PCN# : P57BAAB
Issue Date : Jul. 21, 2015

Information Only Notification

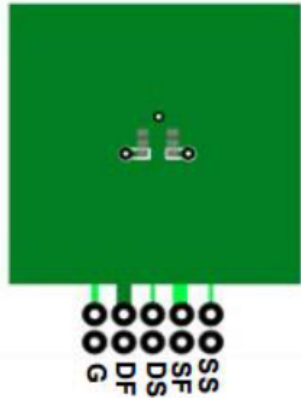
Description of Change (From) :
Old thermal board images in datasheet (Page 2)

Update thermal board images to match the board used in test.

New thermal board images in datasheet (Page 2)
